Architect	TBC
Engineer	HTS Engineers
Contract	Facade Survey, Sunlight House, Manchester, M3 3HP (24008)

Drawing Title
Facade Condition Survey - Atkinson Street Elevation

Drawing No.
24008-PAYE-DR-003 rev P02

ATKINSON STREET ELEVATION (NORTH)

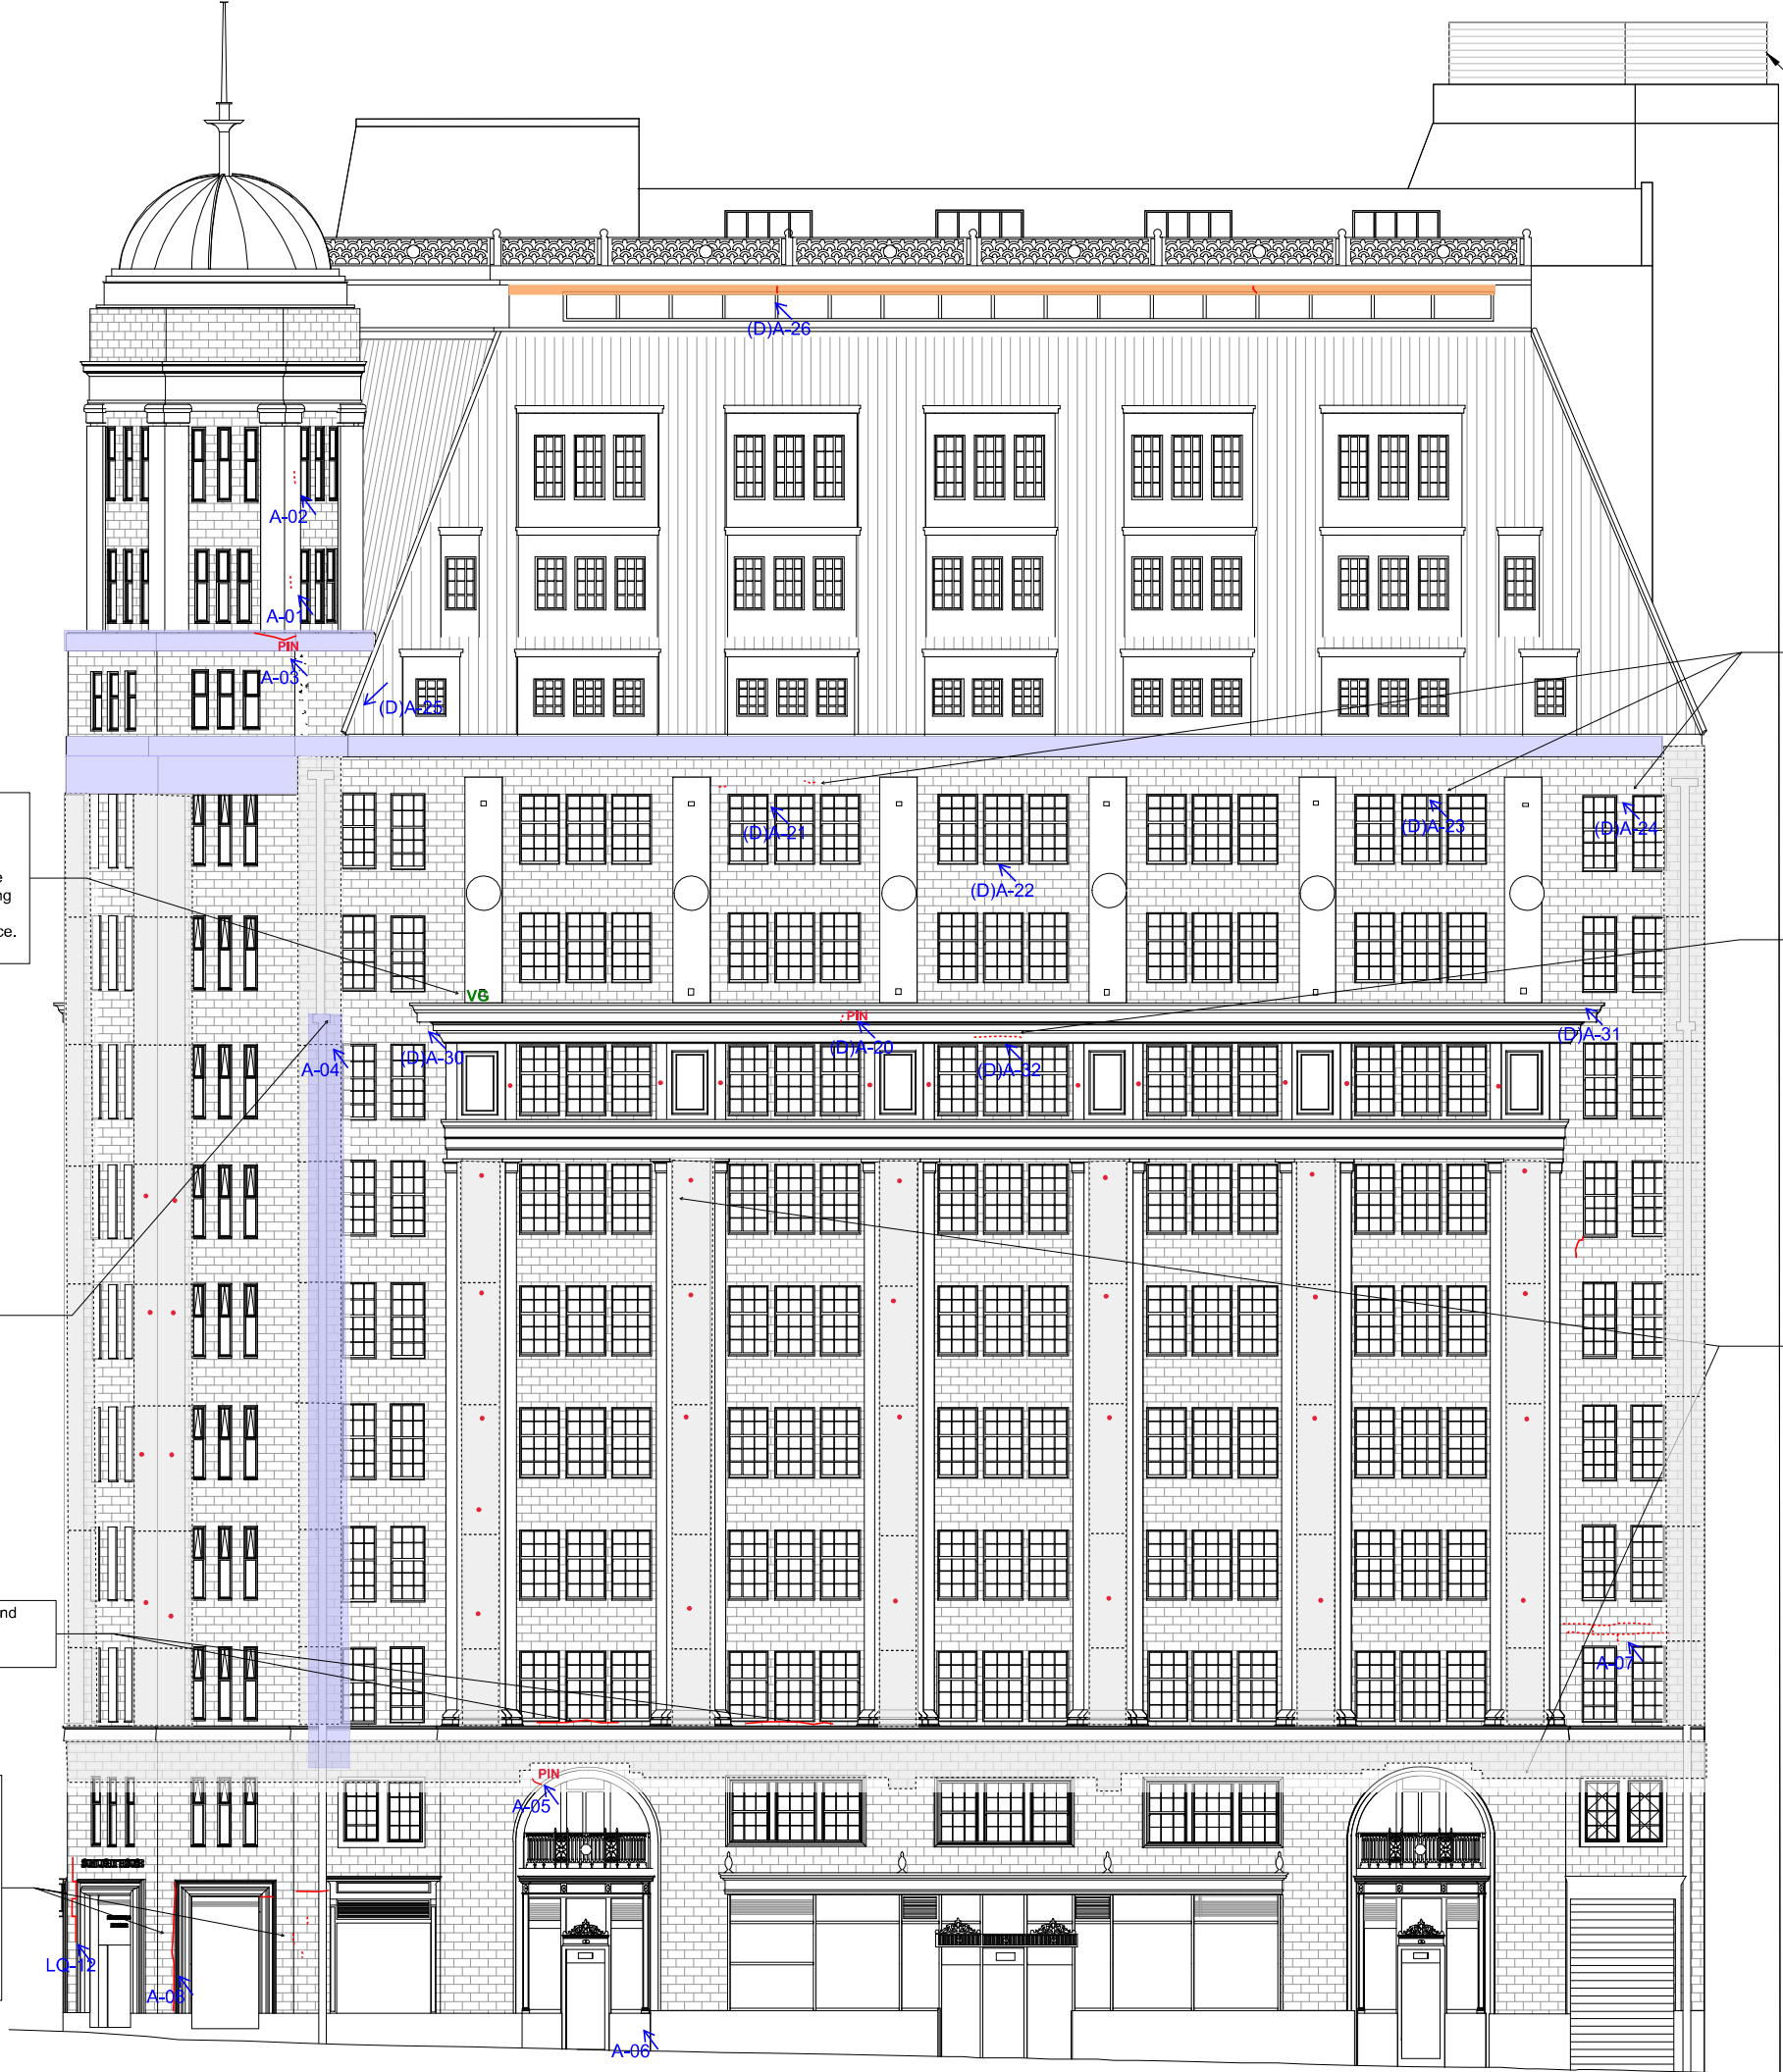
RECOMMEND 100% RAKING OUT AND REPOINTING (SUSPECTED CEMENTITIOUS POINTING)

RECOMMEND 50% RAKING OUT AND REPOINTING

RECOMMEND 100% RAKING OUT AND REPOINTING

Horizontal hairline fractures were observed to a ninth-floor window lintel on Atkinson Street. The stone joint arrangement suggests the likelihood of a steel beam behind. The cause for the fractures may be steel frame corrosion. Although in its infancy, there is a risk that if left untreated it could deteriorate (especially due to the proximity the parapet hidden gutter). Historic mortar repairs were observed to the same bed joint three bays over (see (D/A)-23, 02, which suggest there may have been a historic issue

Hairline fractures (category 0-1) was observed to the decorative frieze band below the cornice. The cause for the fractures may be steel frame corrosion. Strongly recommend consultation with a structural engineer with further investigations undertaken.

There is evidence of extensive historic repairs (possibly to steel frame treatment to all vertical pilasters and to the 2nd floor cornice). It appears;

1. The masonry between the 2nd floor windows and cornice has been replaced (with the exemption of the arched keystones which appear original).
2. All pilasters have been replaced with new 'cladding' built off corbel brackets at every floor level. A silicone movement joint has been included at the new-old stone vertical reveal joint and horizontally at every floor level.

It is strongly recommended to consult with a structural engineer and obtain the as-built drawings and photographs for the extensive repairs to confirm that the works was undertaken to a high standard and align with modern building codes.

The as-built information should confirm; specification for steel frame treatment, thickness of "new" stone, fixing details including corbel brackets and restraints (including materiality), cavity trays and barriers.
